**CITY OF DELAND
REGULAR MEETING OF THE
HISTORIC PRESERVATION BOARD
MAY 1, 2025 AT 5:00 PM
CITY HALL, COMMISSION CHAMBERS
120 SOUTH FLORIDA AVENUE
AGENDA**

1. **Historic Preservation Review (Alteration) of a commercial building at 118 North Woodland Boulevard**
Application No.: HPB25-063
Applicant: Fredrick Peace
Owner: Woodland, LLC

2. **Historic Preservation Review (Demolition) of a residential accessory structure at 403 East Rich Avenue**
Application No.: HPB25-050
Applicant/Owner: Jacqueline & Mark Barden

RE: **Certificate of Appropriateness (Exterior Alteration) for a commercial building at 118 North Woodland Boulevard**
Application No.: HPB25-063
Applicant: Frederick Peace
Owner: Woodland, LLC
Florida Master Site File: 8VO1657

PERSPECTIVE VIEW / ELEVATION NORTH WALL (LOOKING SOUTH)

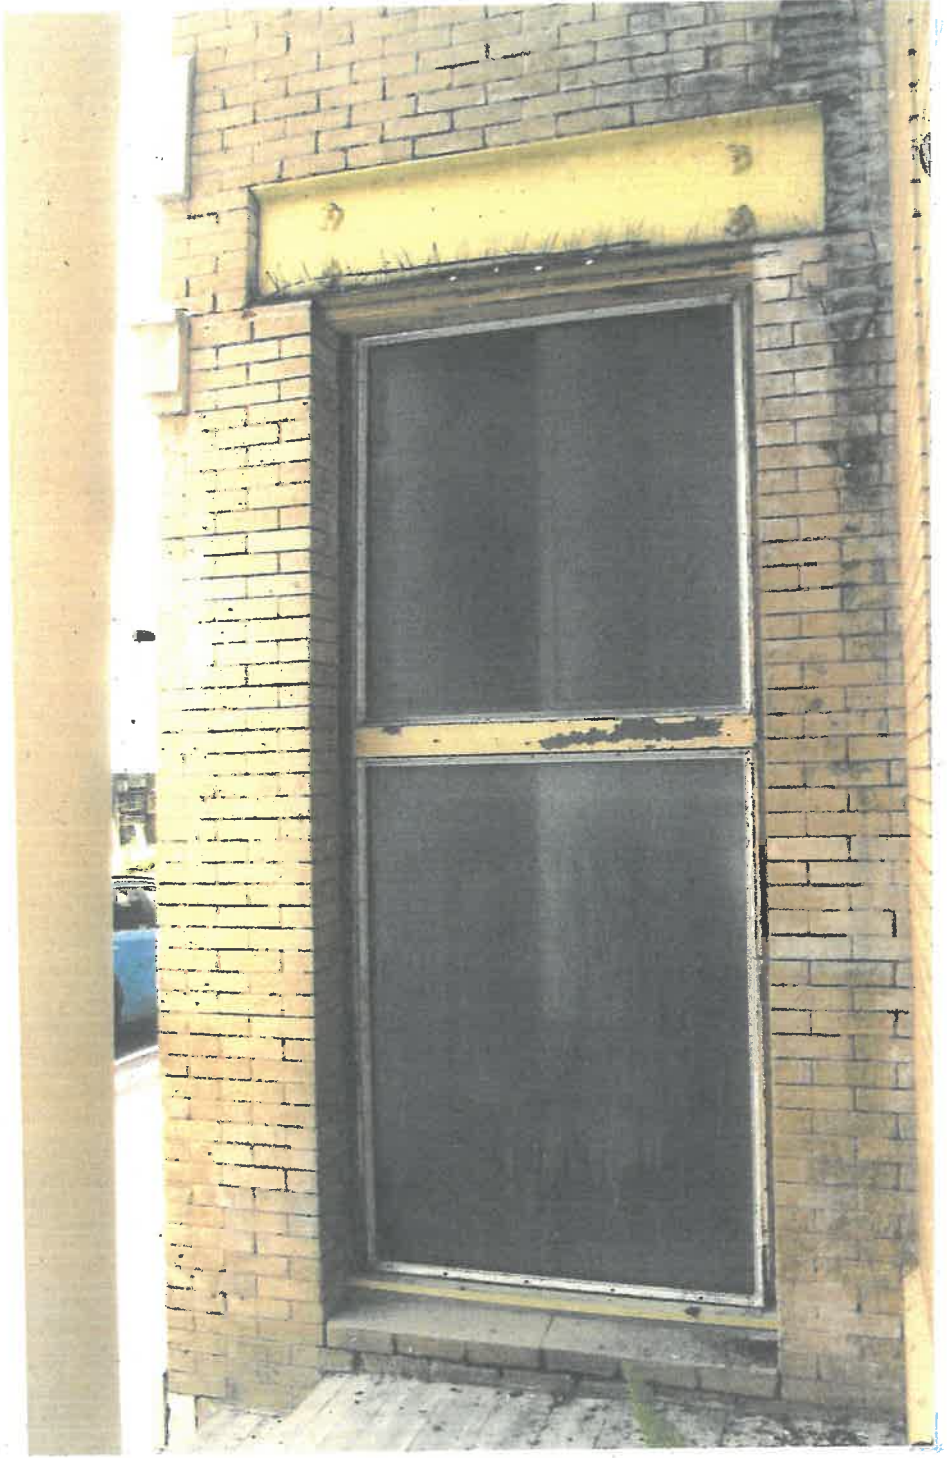
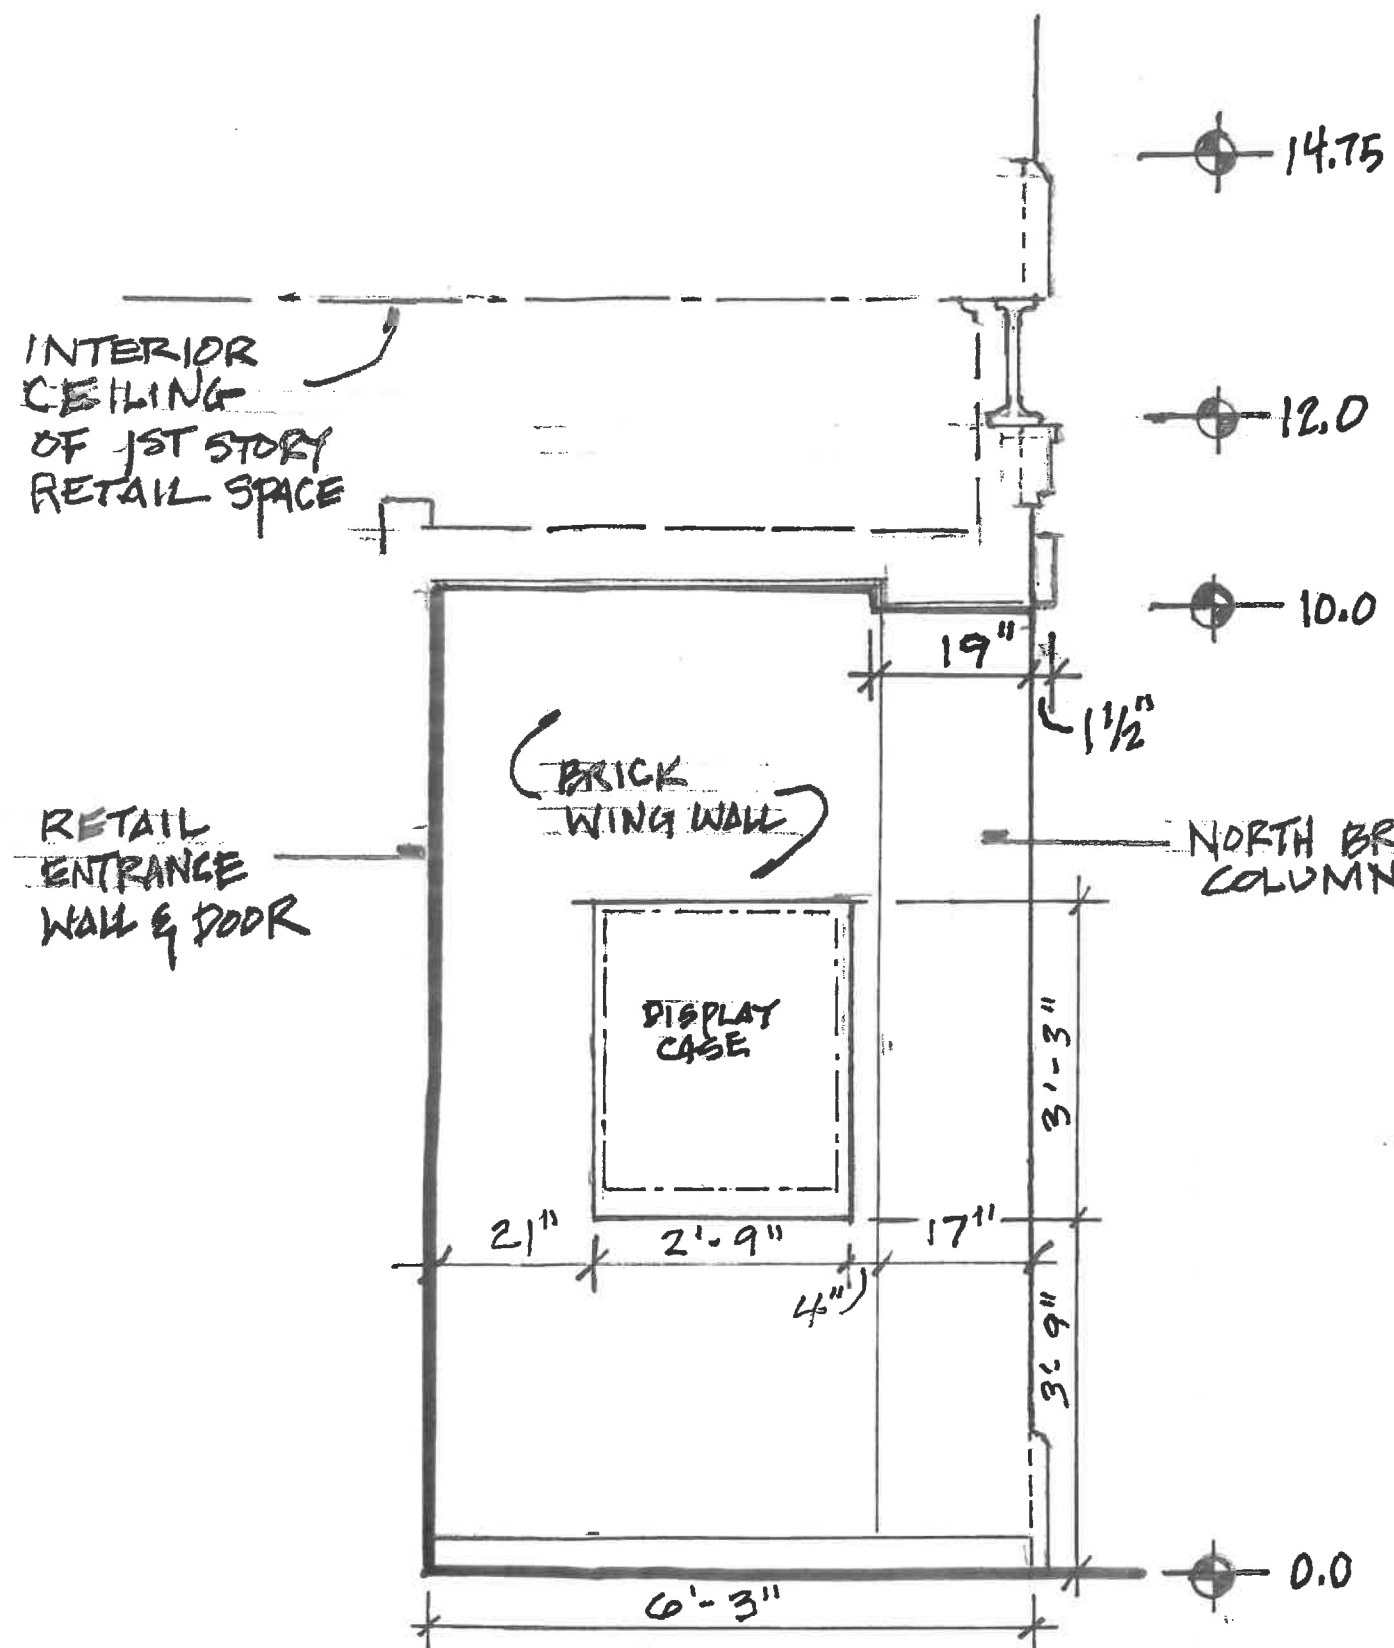
The applicant is proposing to frame in a former display case, on the north brick wing wall, and on the opposite side of the wall, frame in a blind nonfunctioning window, but recess it, resulting in change in the repetition of the relationship of solids and voids in the architectural design, thereby eliminating a portion of the distinctive features and finishes of the building.

Figure 2

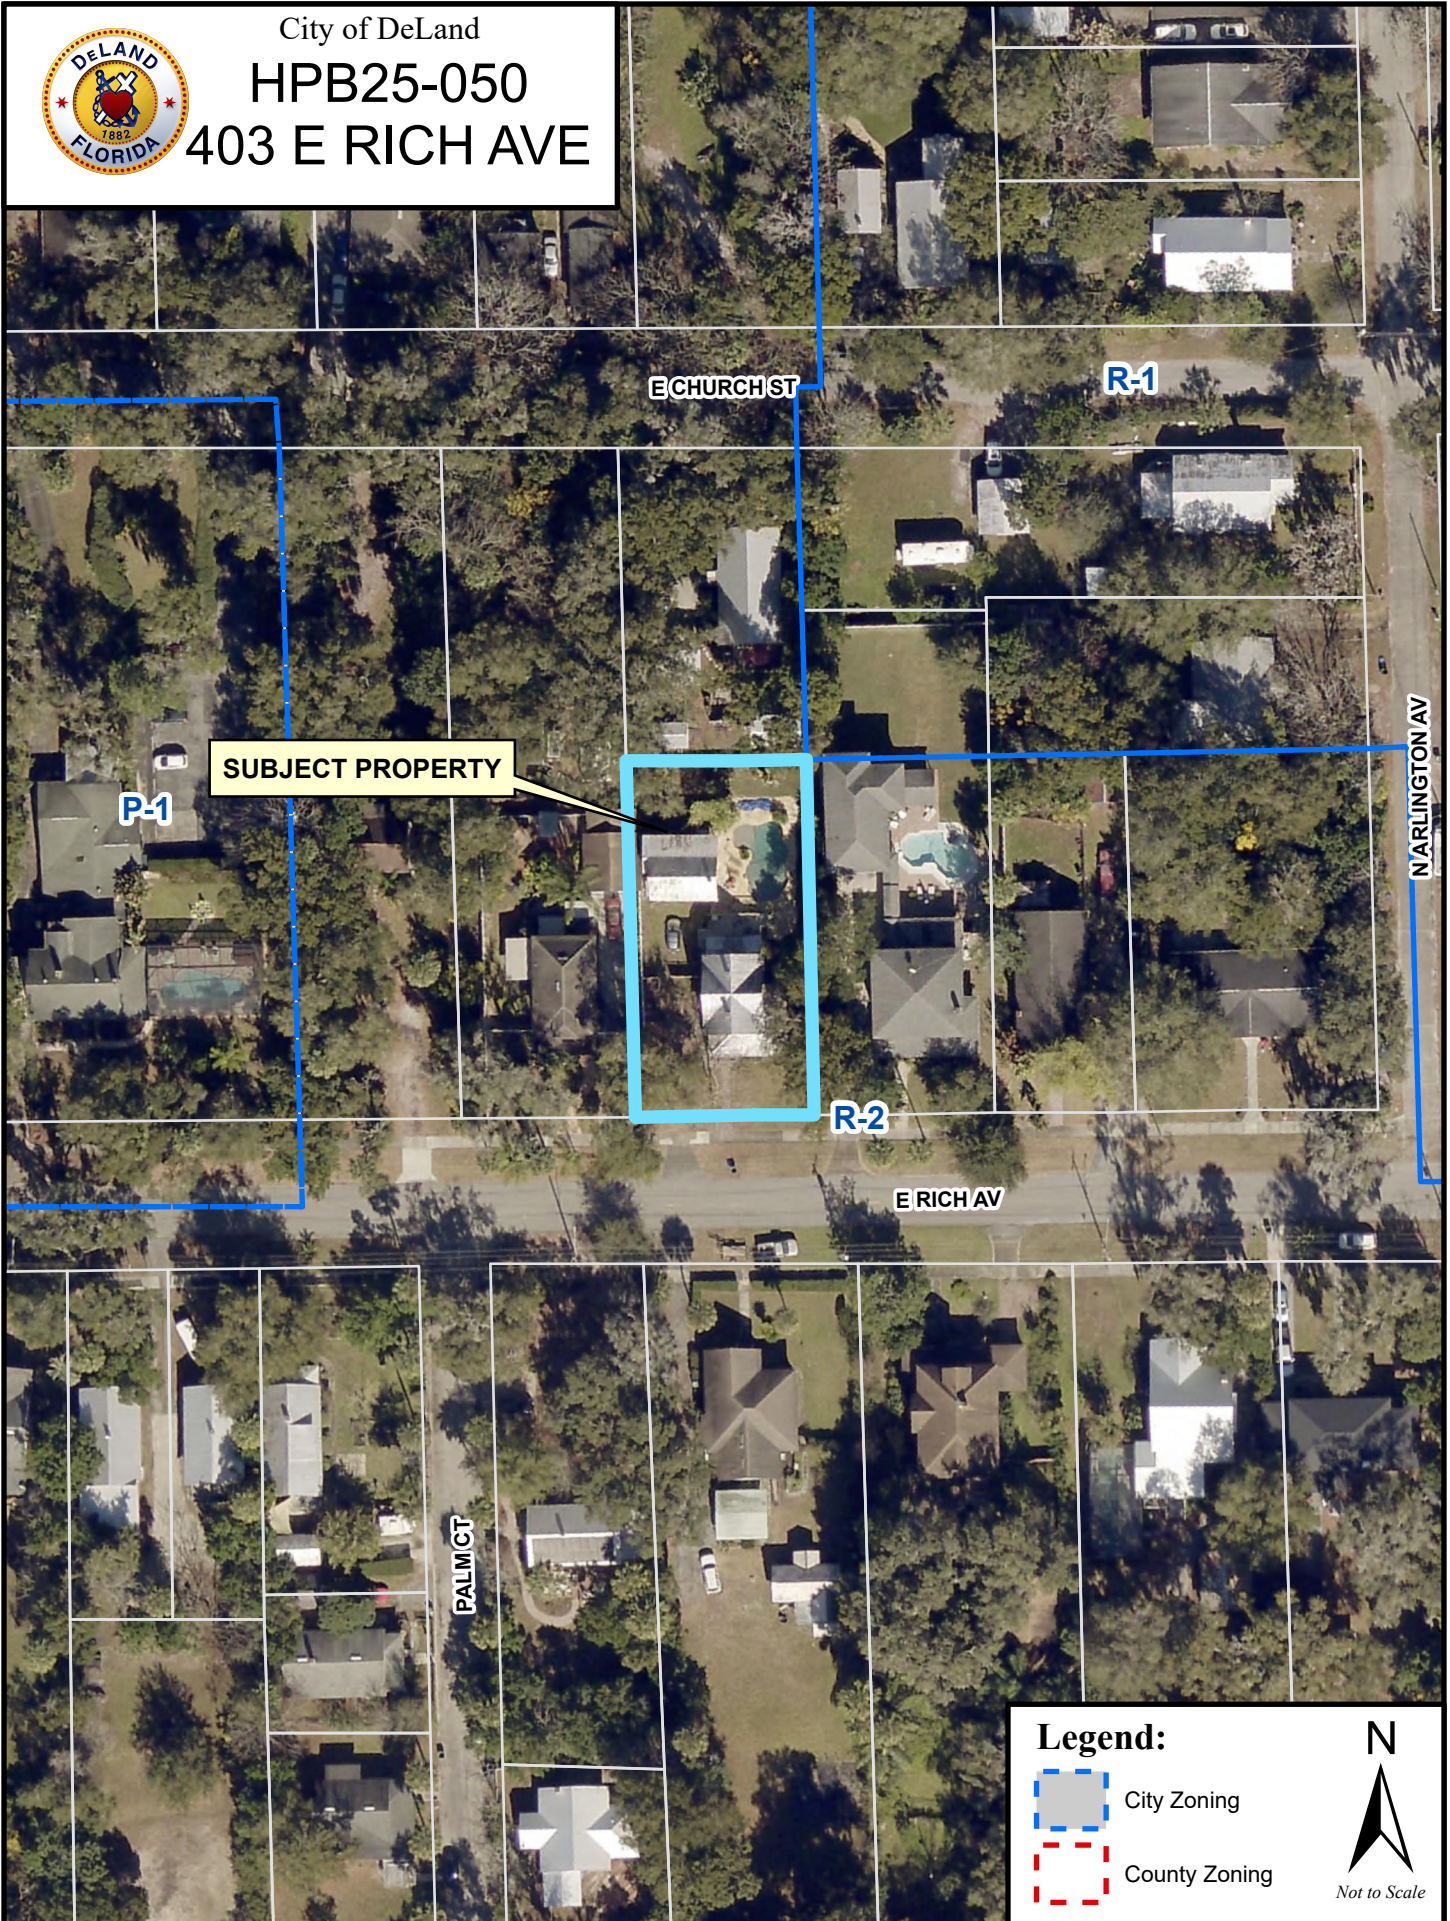
The applicant is requesting to demolish the accessory structure (carriage house) behind the main structure on their property, constructed in 1927 (Figures 1-2). The proposed future use is to rebuild a similar structure for personal use, matching architecturally to the main structure. The proposed floorplan is to have a two-car garage on the first floor and a living space on the second floor, using the existing footprint, contingent upon meeting all required Land Development Regulations and applicable Building Code requirements. Applications for redevelopment plans have yet to be submitted for review.

This accessory structure is one of the last remaining examples of its kind in this neighborhood, as within the surrounding block, the original historic accessory structures have either been completely demolished or demolished and rebuilt with a similar structure. The applicant is proposing to rebuild an accessory structure similar to the property that is immediately to the east of this property (Figure 3).
